# CC-0010 Sandy Springs Phase II Update

November 1, 2016

## Approved City Springs Master Plan Typical Section Sandy Springs Circle (Mt Vernon to Hammond Dr) December 2012

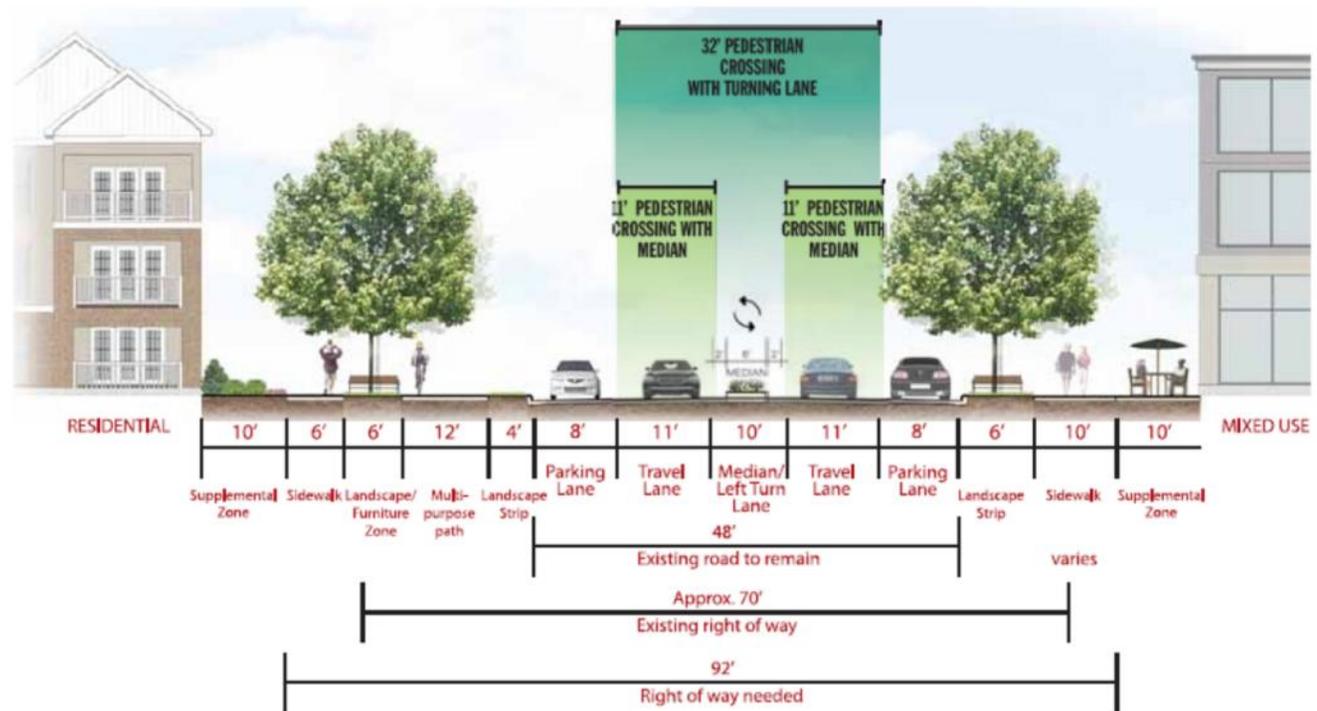
Proposed 3-Lane with parking and path street section

## Public Feedback – August 17, 2016

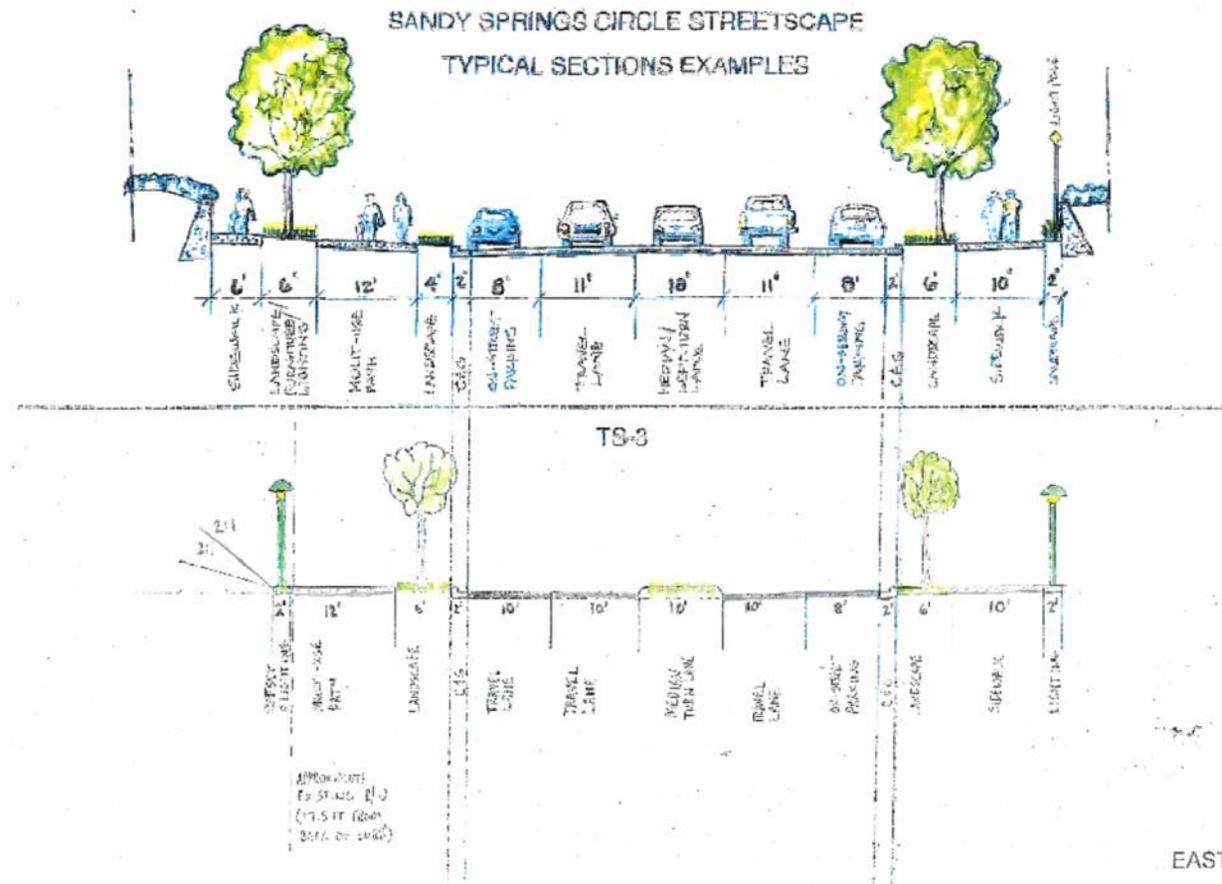
- Right of way acquisition from the original design impacting the SSUMC
- On street parking
- Driveway location to Hitson Center
- Size of retaining wall
- Travel lane reduction

- Reducing right of way acquisition
- Reduce travel lanes to 10' wide from 11ft
- Eliminate parallel parking on western side of road and convert to travel lane
- Eliminate landscape furniture zone
- Eliminate 6ft wide sidewalk
- Reducing the need for retaining walls along SSUMC
